SUPPLEMENTAL INFORMATION REPORT FOR THE
SOUTH SAN FRANCISCO BAY SHORELINE PROJECT

U.S. Army Corps of Engineers

13 November 2020

Appendix A: Public Comments

Figure 2. Reach 1 Proposed Action Changes

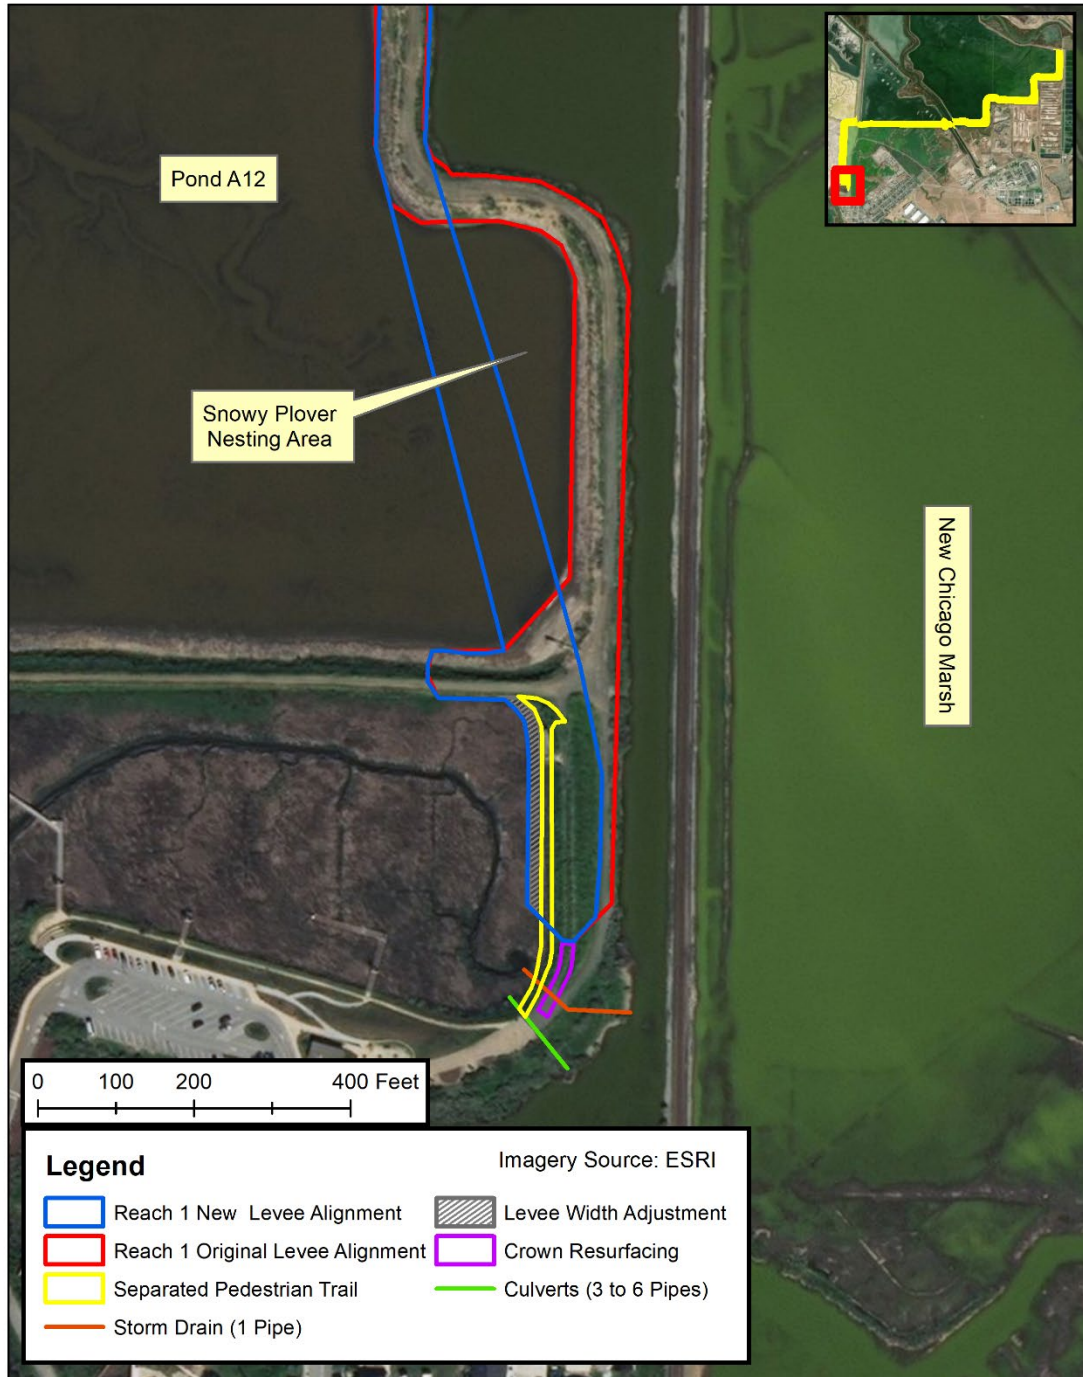
In regard to the Alignment Change proposed in section 3.1, the addition of 1.21 acres of salt panne habitat to the Alviso Impoundment (Impoundment) is unlikely to result in increased Snowy Plover breeding activity in this area. Since 2003, when SFBBO began monitoring Snowy Plover breeding in RU3, including all potential habitat in the Alviso Pond Complex, only four total nests have been found in the Impoundment, including two in 2008 (Robinson et al. 2008) and one each in 2009 (Robinson-Nilsen et al. 2009) and 2013 (Robinson-Nilsen et al. 2013). The Impoundment is often inundated with water, and thus does not frequently provide appropriate breeding habitat for Snowy Plovers (pers. obs.). In order to ensure that breeding habitat is available, water management, whether via a water control structure or manual pumping, would be necessary annually to drain the pond.

Even if water levels are managed to provide dry salt panne habitat, Snowy Plovers are unlikely to breed on the Impoundment due to its close proximity to the public trail. As previously mentioned, Snowy Plovers in RU3 have been found to flush off their nest at an average distance of 479 feet (SE= 62 feet). The majority of the Impoundment, including at the proposed realignment, measures less than 400 feet in width. Unless realignment increases the Impoundment width to at least 541 feet across the Impoundment, and likely wider due to the frequent train activity along the eastern edge of the Impoundment, it is unlikely that Snowy Plovers would breed in this pond regularly. Furthermore, the raised railroad tracks along the eastern edge provide an ideal place for predators to perch. Common Ravens, which are considered one of the main threats to Snowy Plover recovery in RU3 and across the range,

Regarding the paragraph, “Proposed realignment in Reach 1 is inadequate to support breeding Snowy Plovers.” The 'Snowy Plover Nesting Area' included in Reach 1 construction was created due to a levee realignment, and rather than leave the land with no clear purpose, it was decided it could be used as a snowy plover nesting area as a beneficial use of this resource. Fill material would be added into the area and made flat, such that it would no longer resemble a salt panne.

Although this location and size are not ideal, if this area provides even a lower quality habitat compared to other locations, due to the variable availability of more ideal habitat in the area, it could still provide a benefit for the species.

Figure 4. Reaches 4 & 5 Updated Levee Alignment

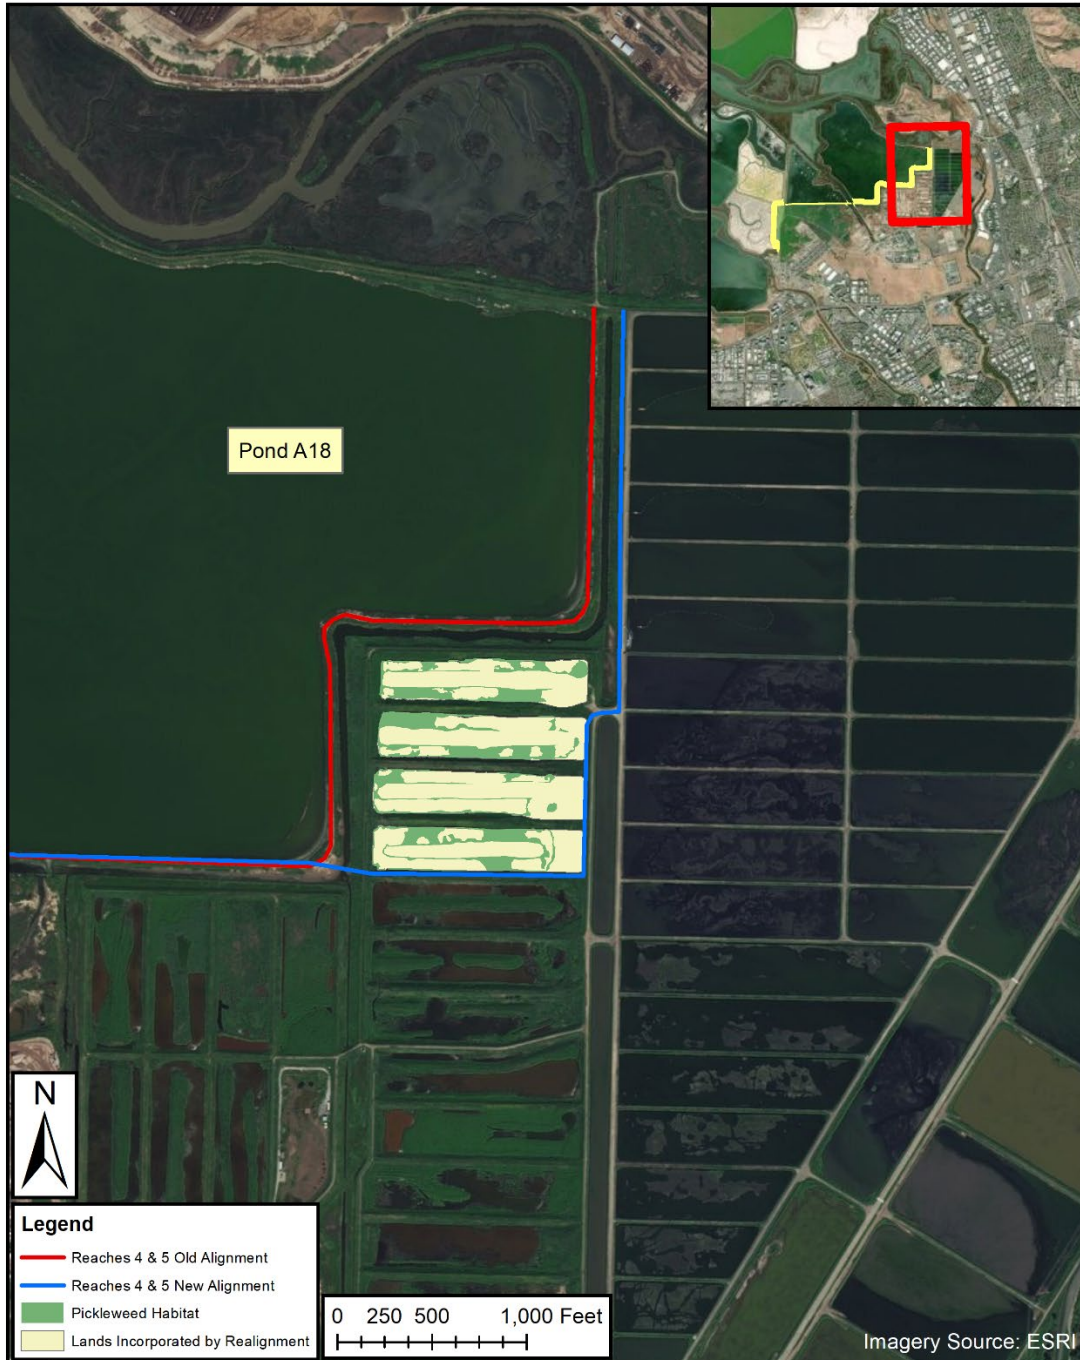
Comment 4: "Please say more about the design of the tie-in to the Coyote Creek levee at the new location coinciding with the existing levee that protects the active wastewater lagoons."

USACE Response to Comment 4: The current design for Reach 5 is only at a 30% design level. As such, more detailed information on the tie-in, more than what was already included in the FID and this SIR, is not available at this time.
